<b>Docket Number:</b>	09-AFC-05C
<b>Project Title:</b>	Abengoa Mojave Compliance
<b>TN #:</b>	253380
<b>Document Title:</b>	Mojave Solar Project Comments - Mojave Solar Pond's Liner Extension Project - Petition to Amend
<b>Description:</b>	N/A
<b>Filer:</b>	System
<b>Organization:</b>	Mojave Solar Project
<b>Submitter Role:</b>	Applicant Representative
<b>Submission Date:</b>	11/29/2023 1:32:57 PM
<b>Docketed Date:</b>	11/29/2023

# **Petition To Amend**

## **Pond's Liner Extension Project**

**Mojave Solar**

Scale: 1" = 80'	EVAPORATION PONDS ALPHA SITE LINER EXTENSION LIMITS	Plan No: Sheets: 2 Sheet No: 1 Plan No. Int:
--------------------	---	---

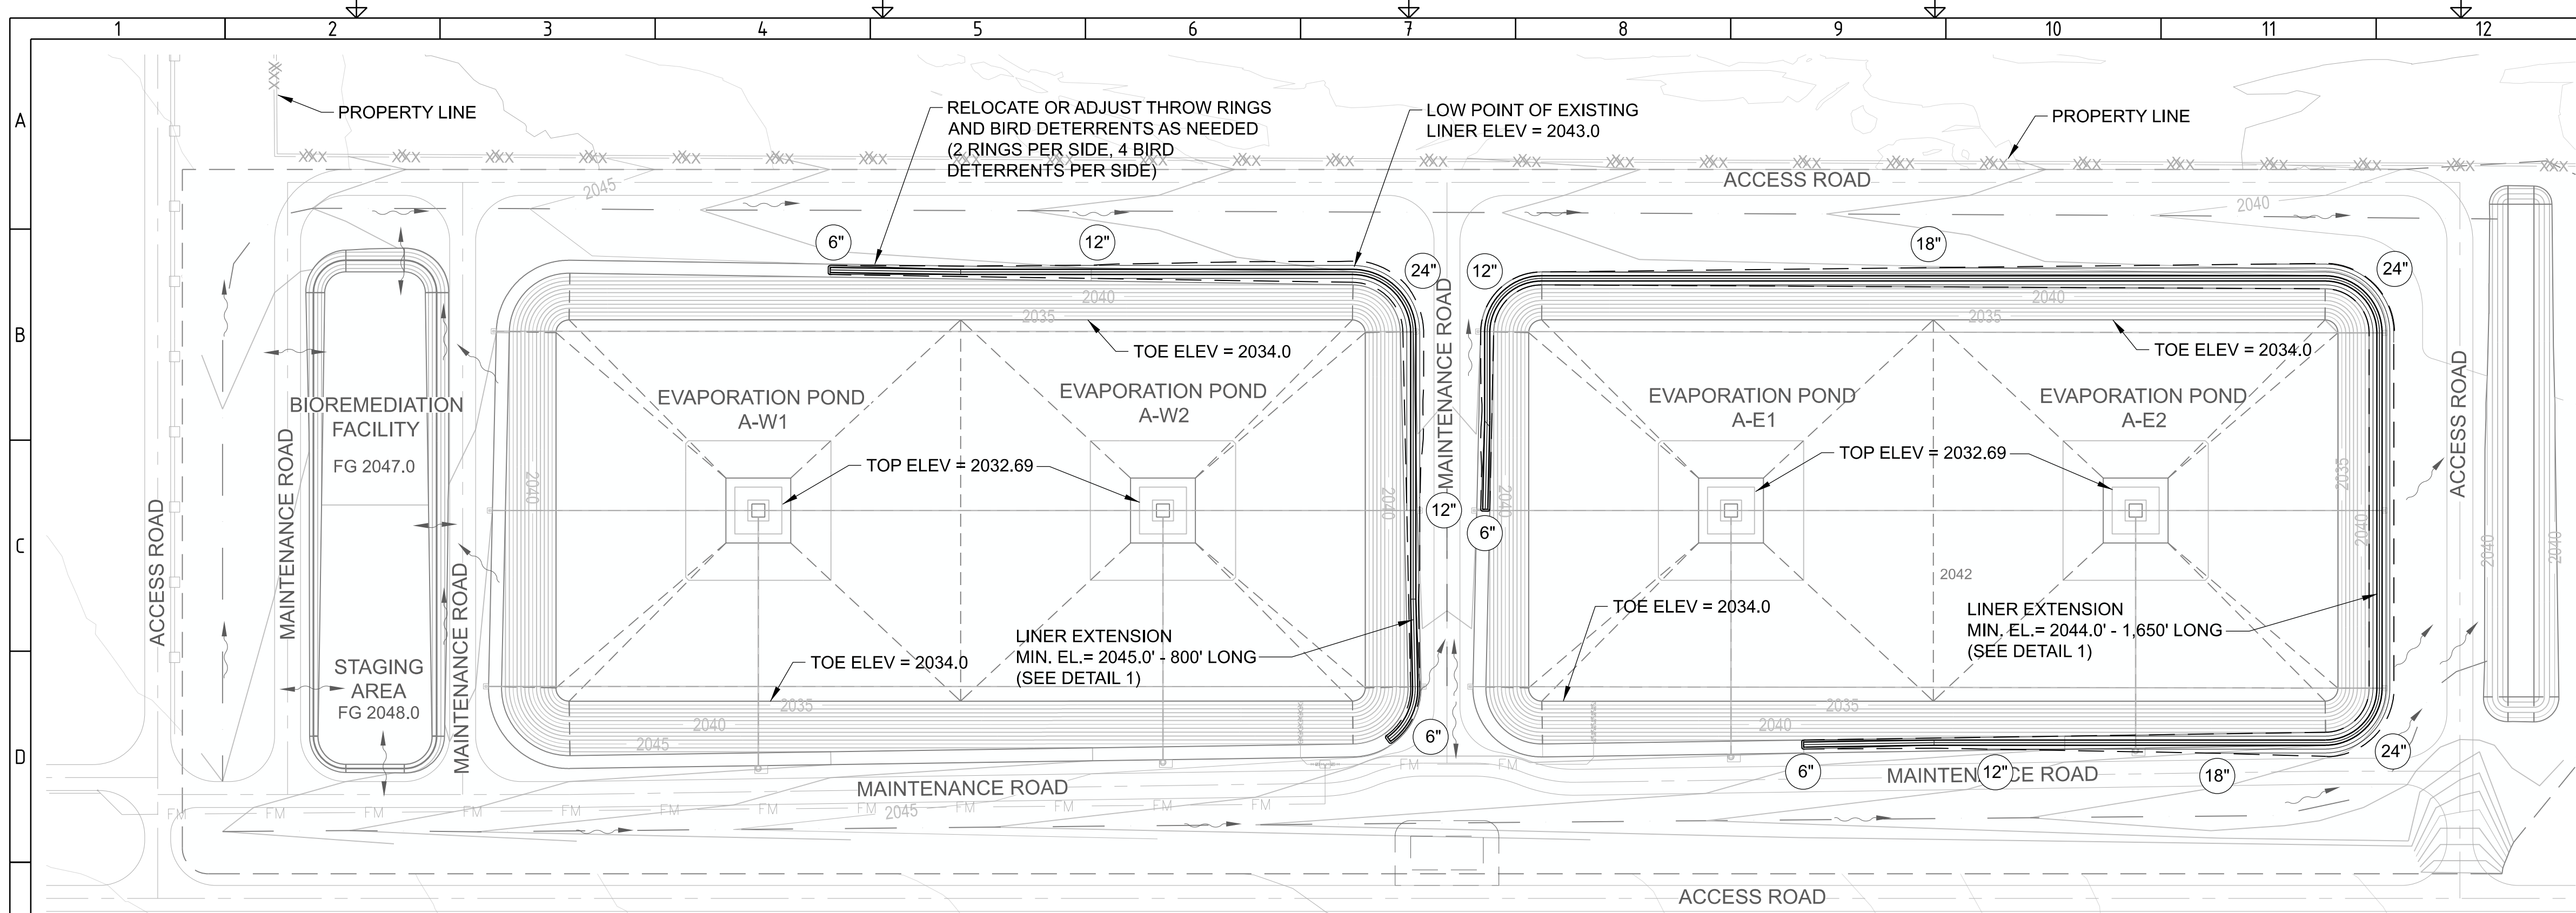
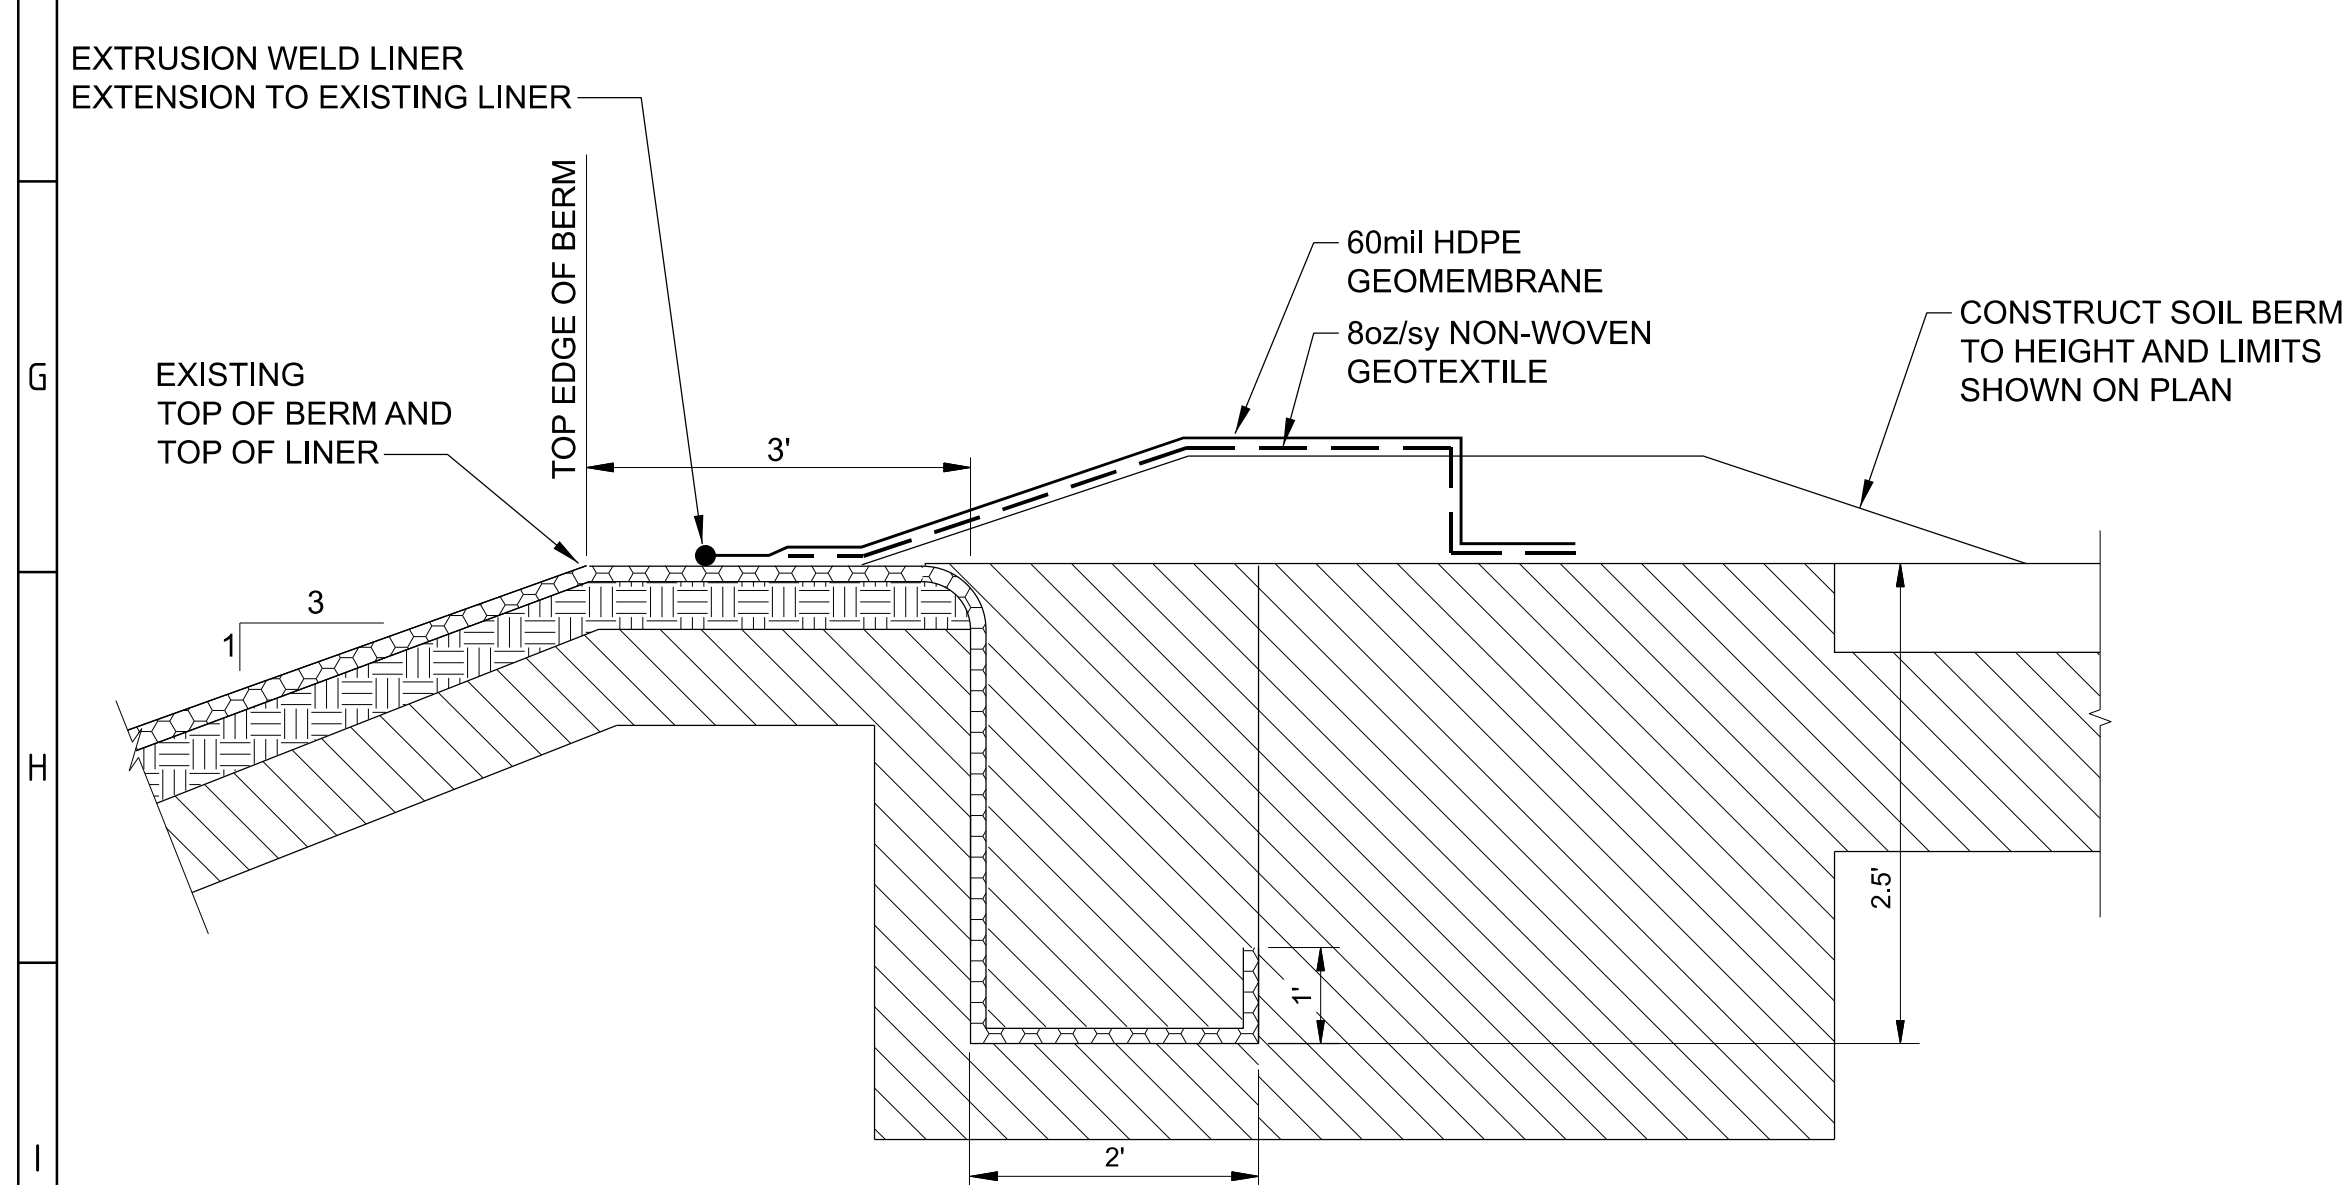
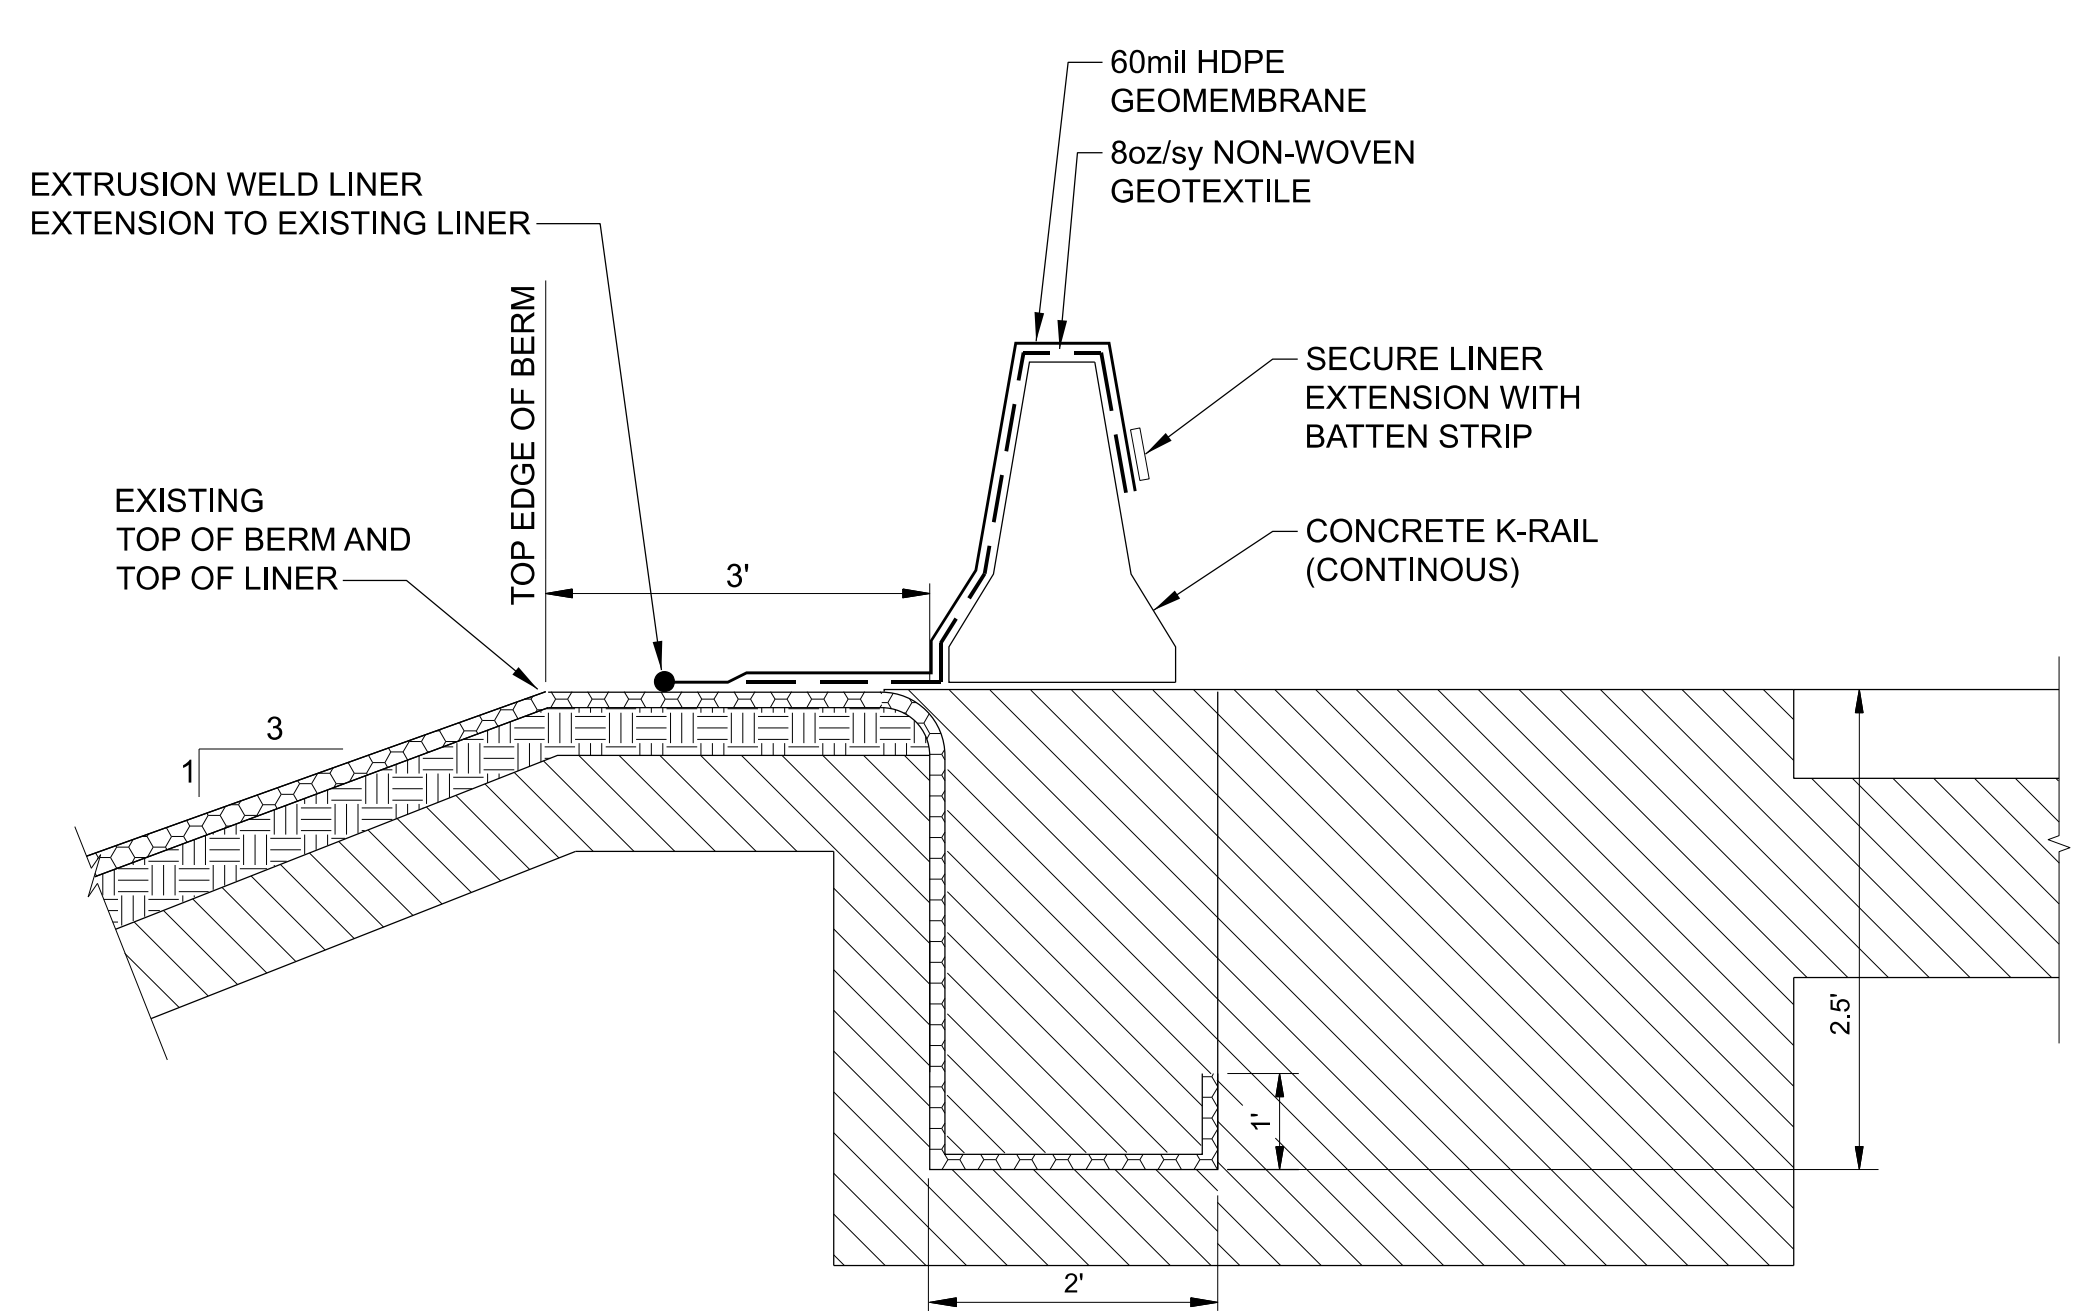
HAI has prepared design plans for the construction of the liner extensions. The concept of the liner extension is to provide a 60 mil HDPE liner that extends the lower (in elevation) areas of the ponds by up to 2.0 feet. The ponds are required to maintain 2.0 feet of freeboard to ensure containment of the liquids stored in the ponds. The 2 feet of freeboard is a common requirement of dams and wastewater containment ponds. The 2.0 feet of freeboard provides a reasonable amount of containment in the event of storms, wave action, or emergency events to ensure that overtopping will not occur.

Based on the above, HAI has developed the design plans for construction of the liner extension for both the Alpha and Beta Ponds. Each pond is independent of the others and therefore, the liner extensions can be constructed individually or as a group depending on MSP's need and budget. The design plans are attached as Sheets 1 and 2. Appendix 10.1
